1 H@NC - 20 Eagle Crest Court, Lillington, NC 27546

# The Holly - LH 'GEORGIAN' ELEVATION

10-22-2024 - Redlines - JJ

THE HOLLY - LH  
Cover Sheet 'Georgian'

**FIRST FLOOR PLAN 'GEORGIAN'**

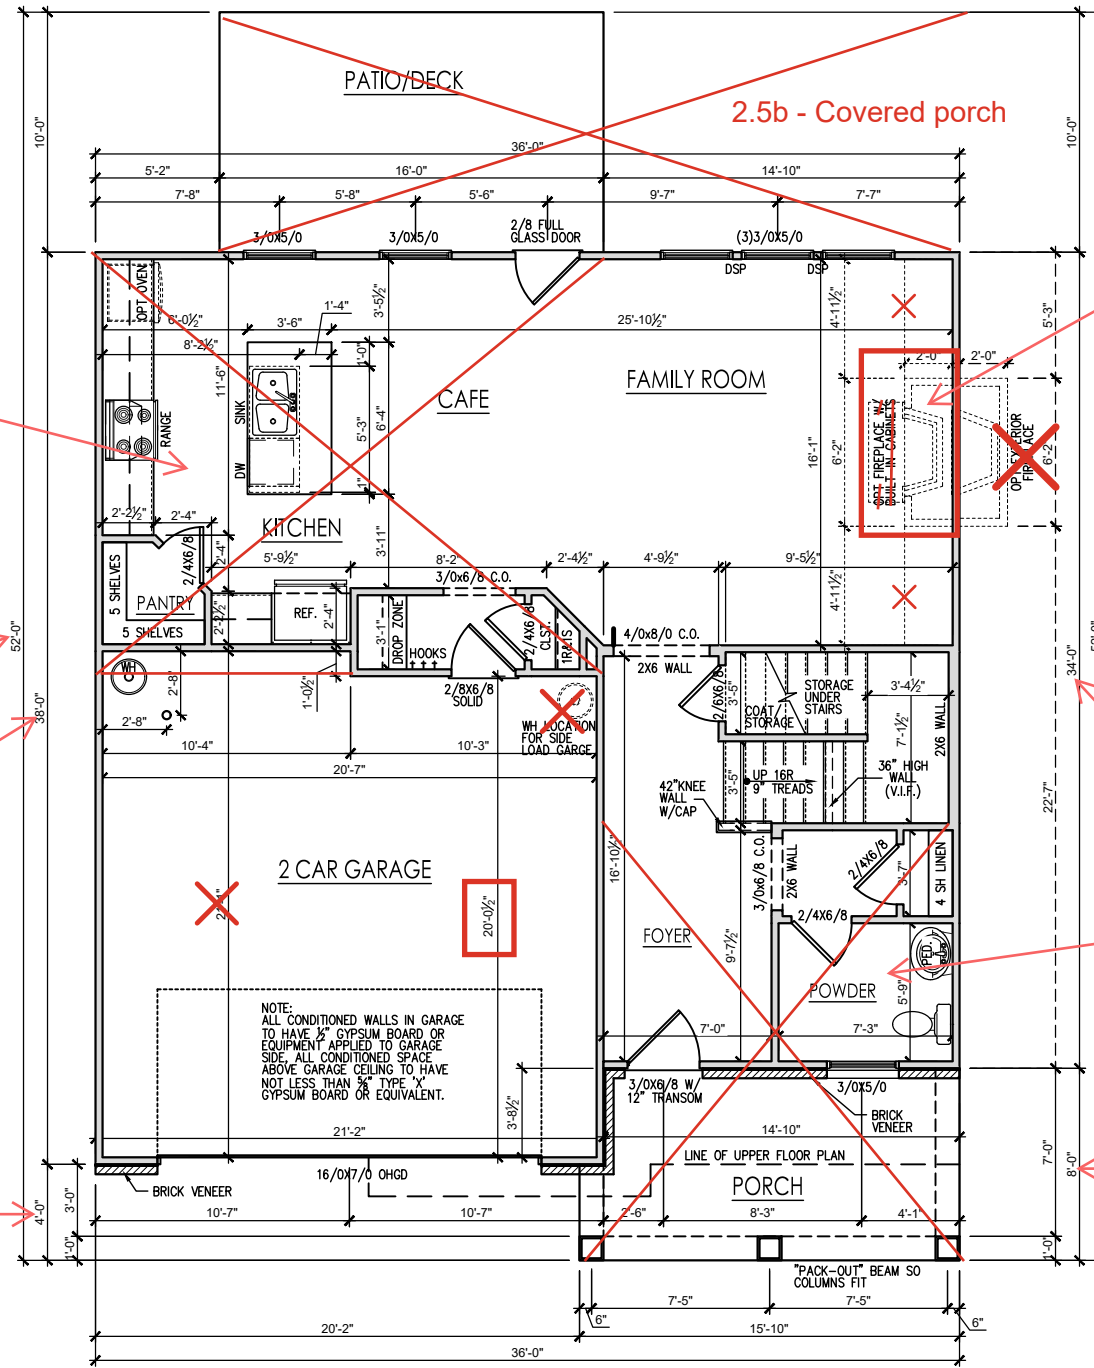
2.1.1b - kitchen, ext cafe, messy kitchen, pantry & garage wall

54'-0" overall

38'-0" dim

6'-0" porch dim

2.5b - Covered porch

2.1.1b - fireplace

54'-0" overall

38'-0" dim

2.1.1b- Smart Door delivery, Pocket office and powder room

6'-0" porch dim

**SECOND FLOOR PLAN 'GEORGIAN'**  
SCALE: 1/8"=1'-0" ON 11x17, 1/4"=1'-0" ON 22x34

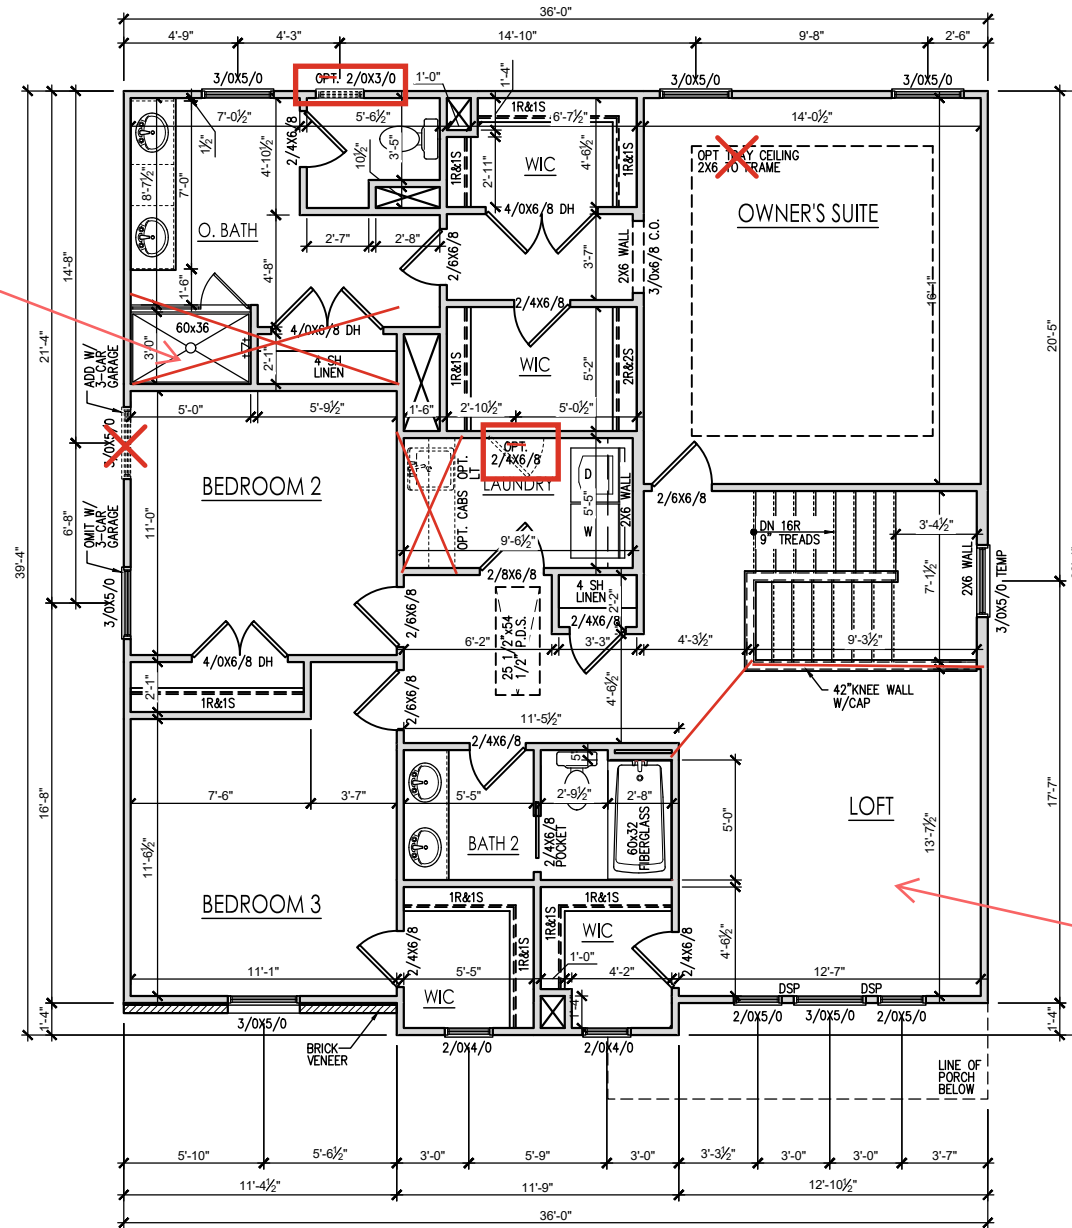
2.2.1 - tub & shower w/ seat

**LEFT SIDE ELEVATION 'GEORGIAN' (SLAB)**  
SCALE: 1/4" = 1'-0" ON 22x34, 1/8" = 1'-0" ON 11x17

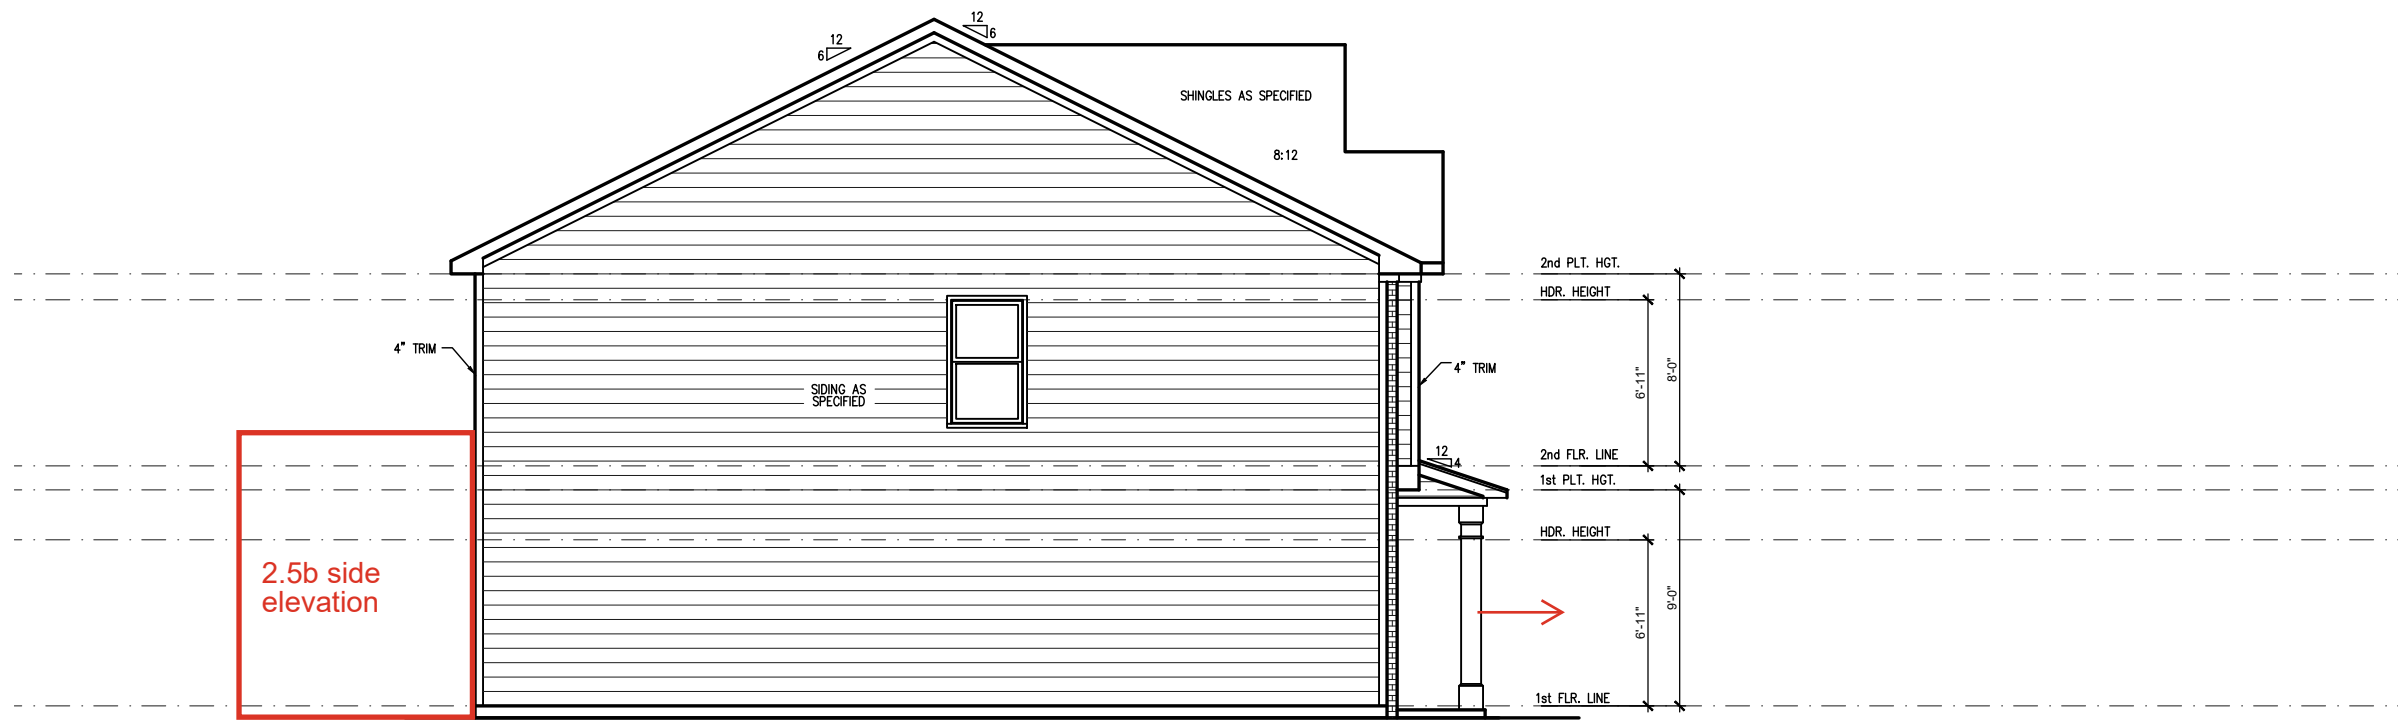
2.5b side elevation

2.5b side elevation
